**Notice of Intent**

**HILCORP ENERGY COMPANY**  
**Sunray E 2B**  
**NOTICE OF INTENT TO PERMANENTLY ABANDON**

AFMSS 2 Sundry ID 2755037

CONDITIONS OF APPROVAL

## Sunray E 2B - PROPOSED P&A SCHEMATIC

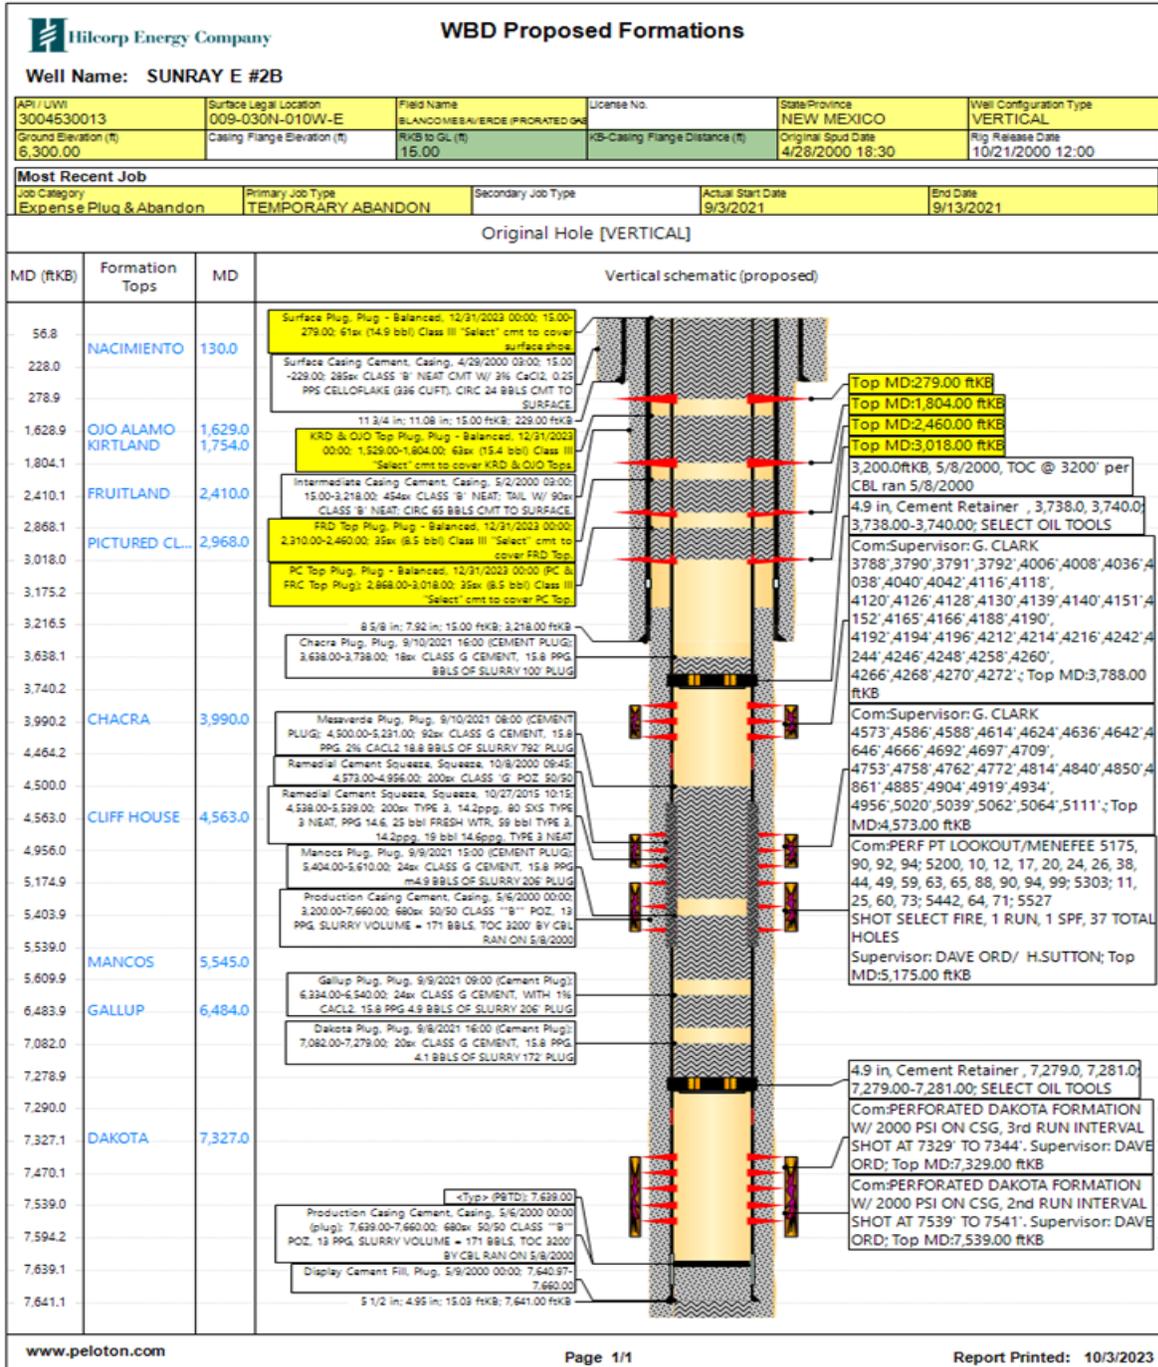
You are also required to place cement excesses per 4.2 and 4.4 of the attached General Requirements.

Created By	Condition	Condition Date
mkuehling	If pressure on bradenhead - kirtland and ojo plug will need to be separated - Notify NMOCD 24 hours prior to moving on.	10/16/2023
